Fiat 500 Service Schedule Additional Procedure

Please be aware that within the scheduled servicing operations there has been added a specific check procedure for checking the condition of the front brake hoses on Fiat 500.

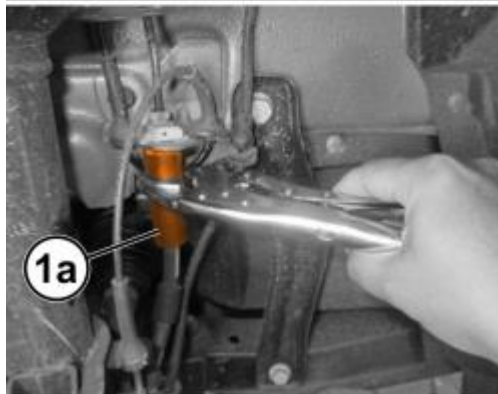
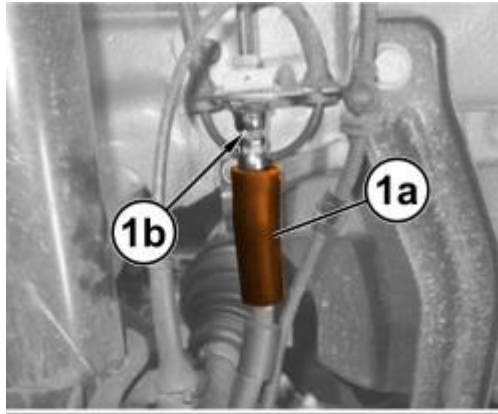
1. Move the rubber protection (1a) away until the connection (1b) of the brake hose line is completely uncovered.

If necessary, use a suitable vice to facilitate the release of the protection

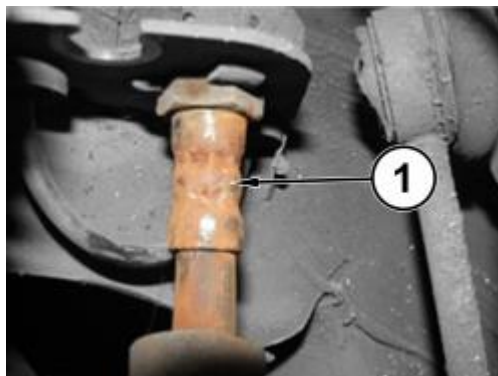
- Clean the fitting using "SOCOSAT A2501" wipes (or equivalent product).
- Blow compressed air onto the surface. Examine the brake hose connection.

3. If there is rust and the connector is NOT damaged, proceed as follows:- Apply the "LOCTITE SF 7500" anti-rust agent (or equivalent product) using a suitable brush, taking care to apply it also to the rear part of the fitting.- Wait 20 minutes for the product to dry and then restore rubber protection.
